**PLANNED UNIT DEVELOPMENT
& SUBDIVISION STAFF REPORT****Date: December 6, 2012****DEVELOPMENT NAME**

West Mobile Boulevard Center Subdivision

LOCATION6575 Airport Boulevard
(South side of Airport Boulevard, 675' ± East of Providence
Hospital Drive)**CITY COUNCIL
DISTRICT**

Planned Unit Development Approval to amend a previously approved Planned Unit Development to allow shared access between multiple building sites and Subdivision approval to create six legal lots of record from three existing legal lots of record.

SITE PLAN

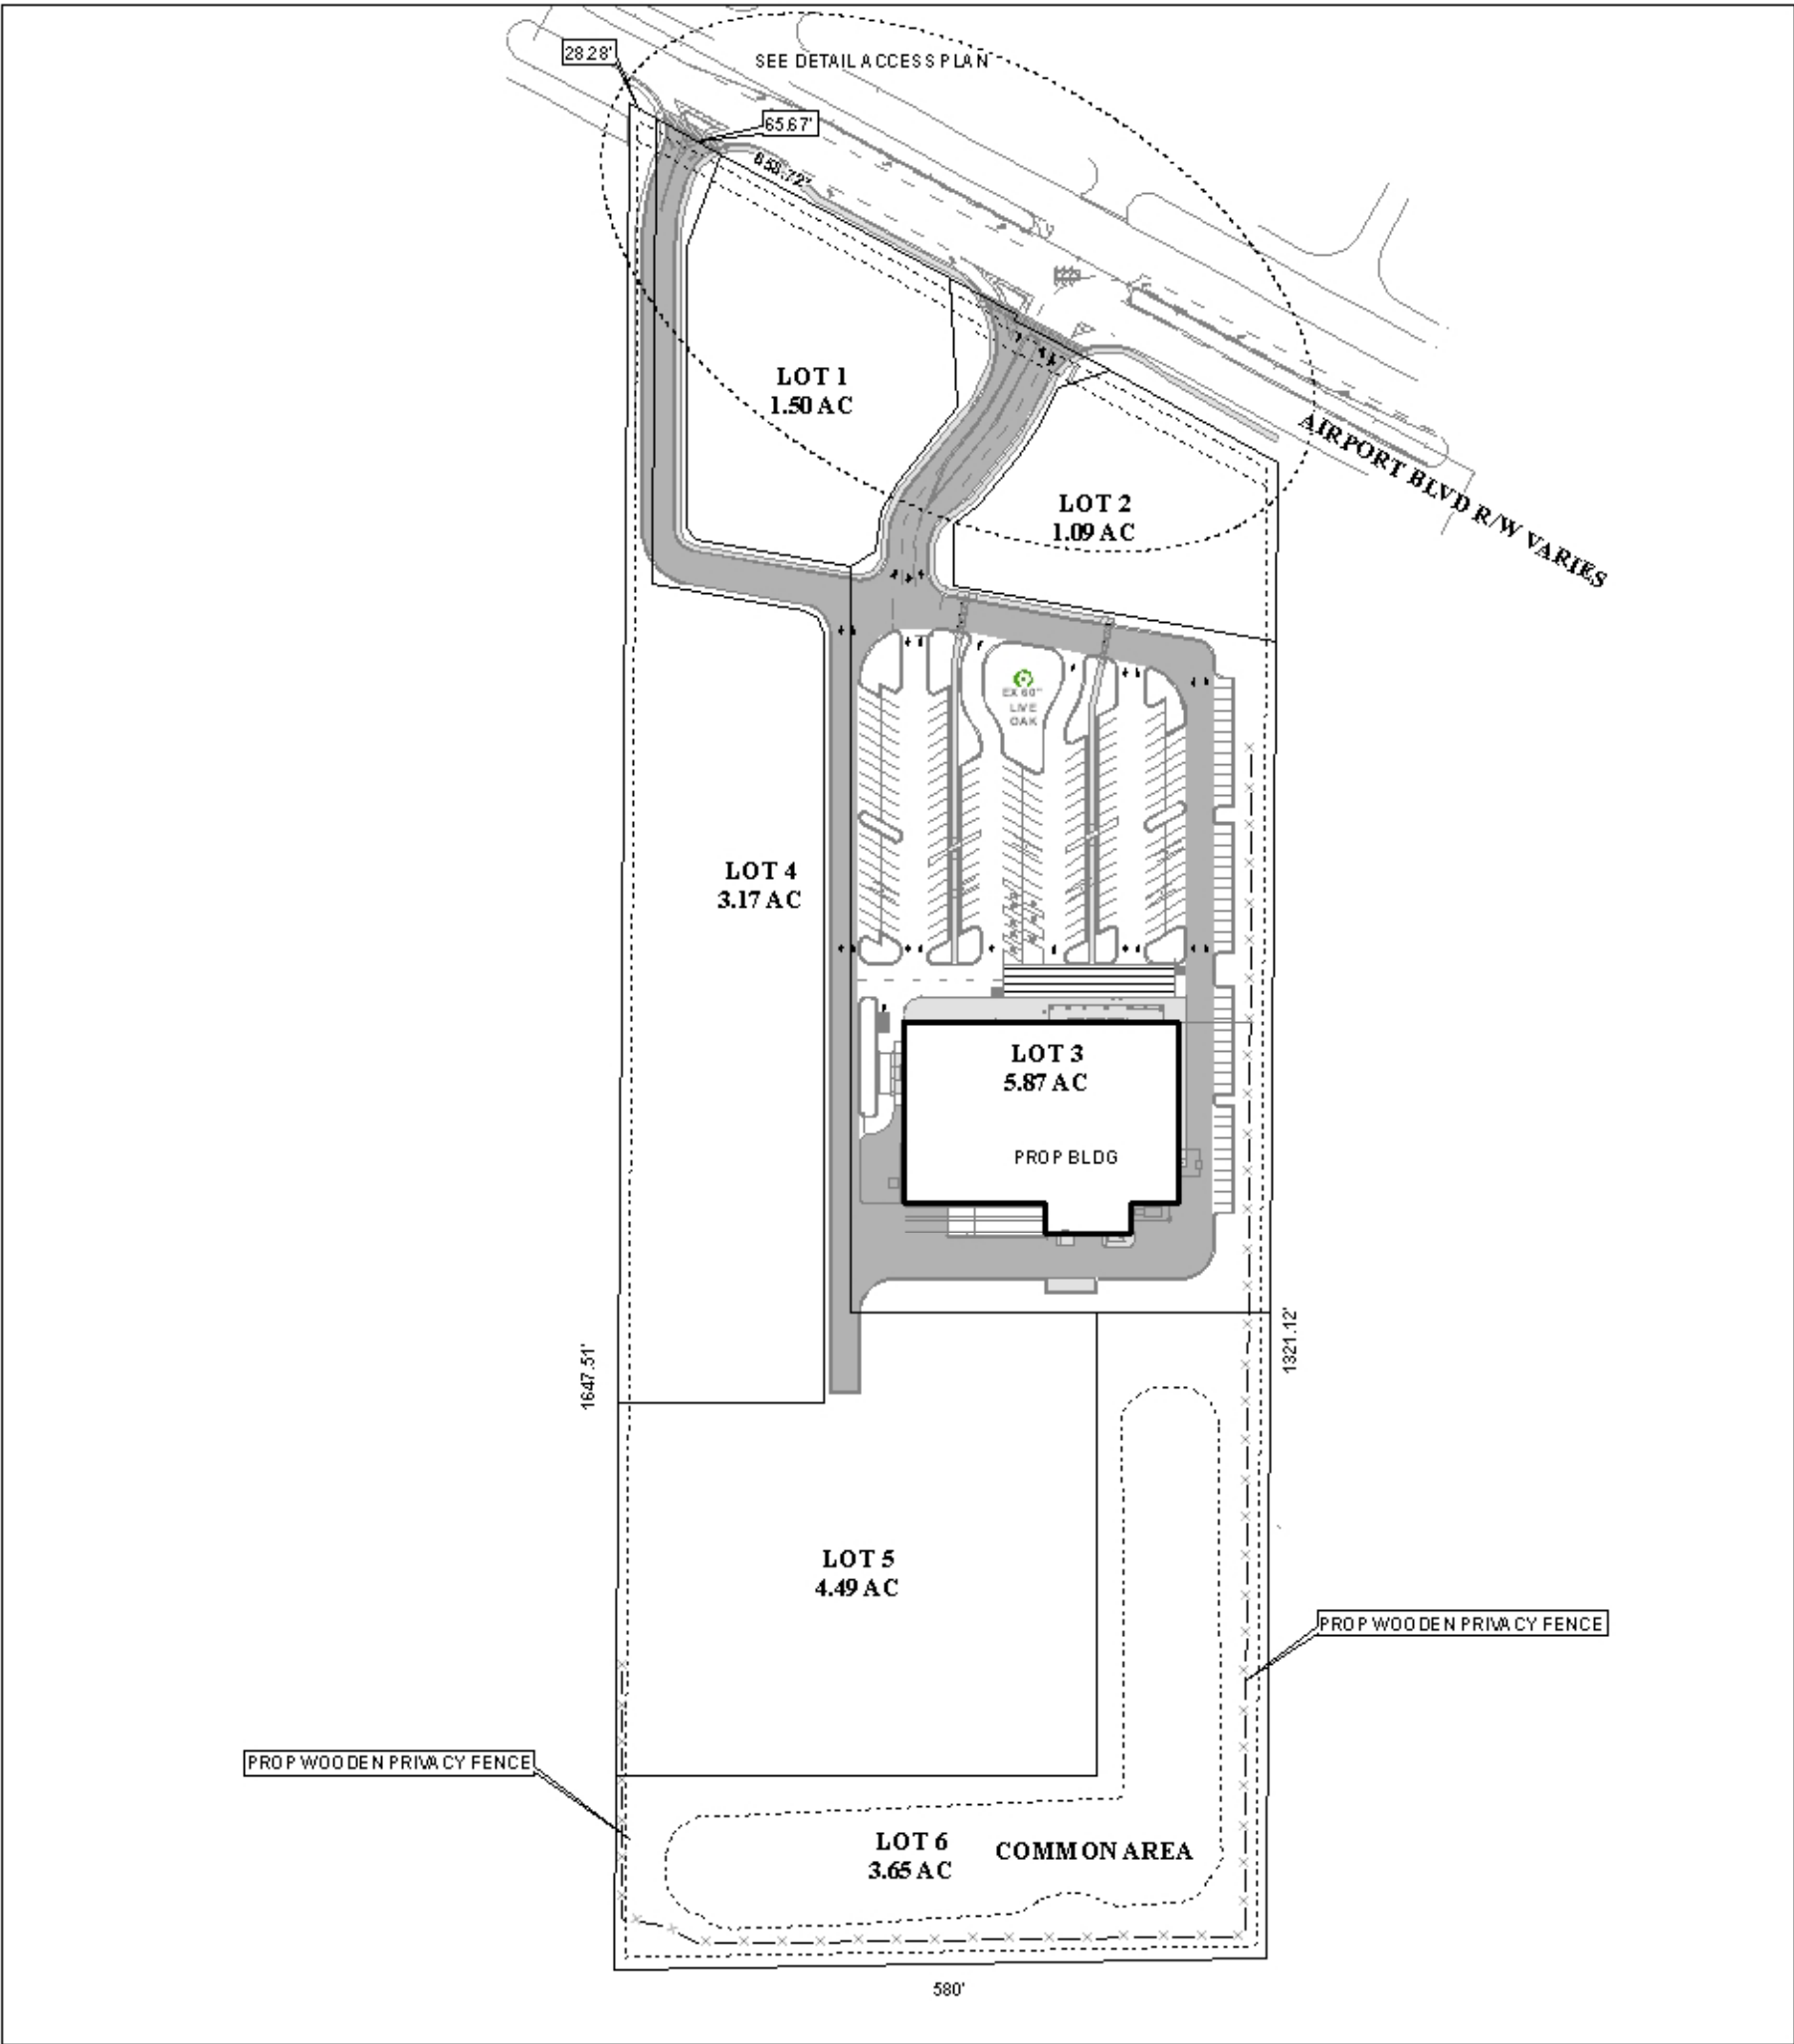
A city standard sidewalk is indicated along the Airport Boulevard and would be required in compliance with the developmental standards of Engineering. In addition, the site plan does indicate a dumpster and contains a note stating the proposed buffering. However, the site plan should be revised to indicate the dumpster is in compliance with Section 64-4.D.9. of the Zoning Ordinance, with a compliant sanitary sewer connection.

Parking spaces provided exceed the required ratio by approximately 47 percent for the proposed development of Lot 3, which is located in a B-3, Community Business District, and access ways and maneuvering areas comply with the requirements of the Ordinance.

The plan does illustrate one common area, of approximately 3.65± acres noted as Lot 6 on the preliminary plat, if approved, the area should be labeled as retention/detention/common area (not Lot 6) on the Final Plat and should include a note stating that maintenance of the common area is the responsibility of the property owner(s).

The site abuts R-1 zoned property to the South; therefore, the provision of a 10-foot buffer strip or an 8-foot privacy fence should be required where the site abuts residentially zoned property as per Section 64-4 of the Zoning Ordinance.

The site plan does not illustrate the location or number of the tree planting requirements of the Ordinance. Therefore, a condition of approval should be that the development comply with the landscaping and tree planting requirements of the Ordinance.

DETAIL ACCESS PLAN

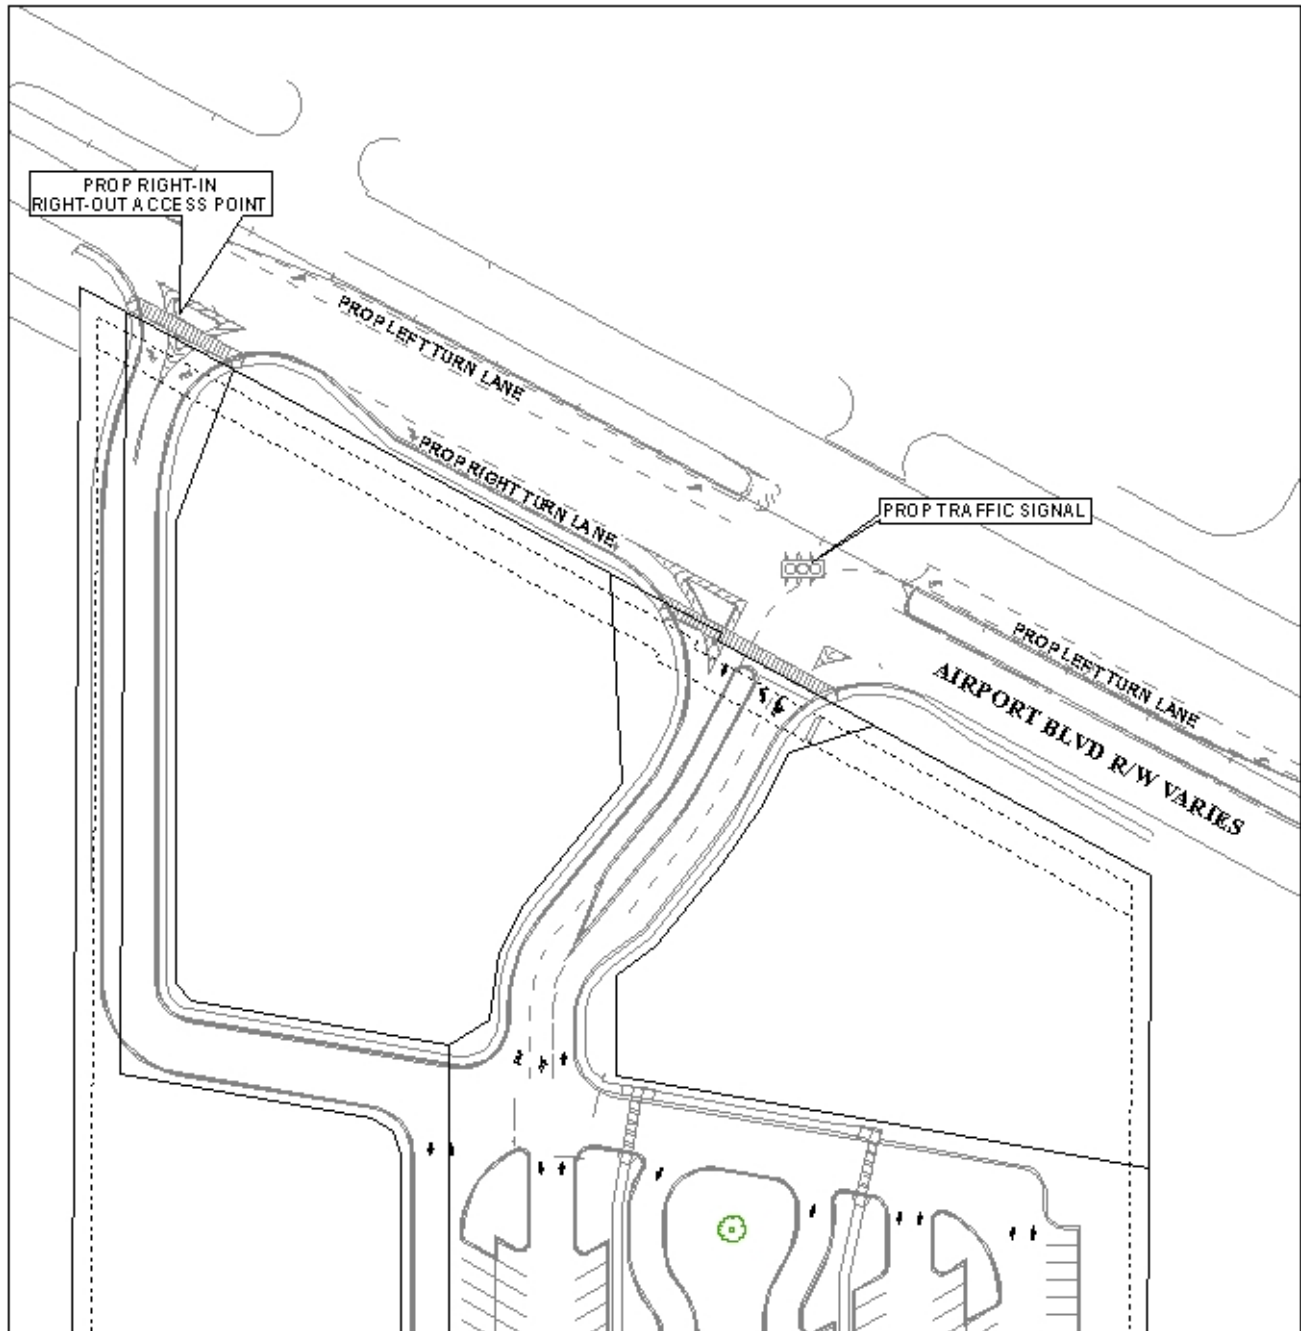
The site is located on Airport Boulevard, a major street on the city's Major Street Plan; therefore, access to Airport Boulevard is a concern. The plan as submitted indicates two access points to Airport Boulevard, one of which would require a new median cut and signalization. A second access point to the site is along the west side of the site. As previously mentioned, the site plan illustrates the same number and size of the previously approved subdivision and PUD with the only change in the addition in the number of lots and the design of Lots 4 and 5.
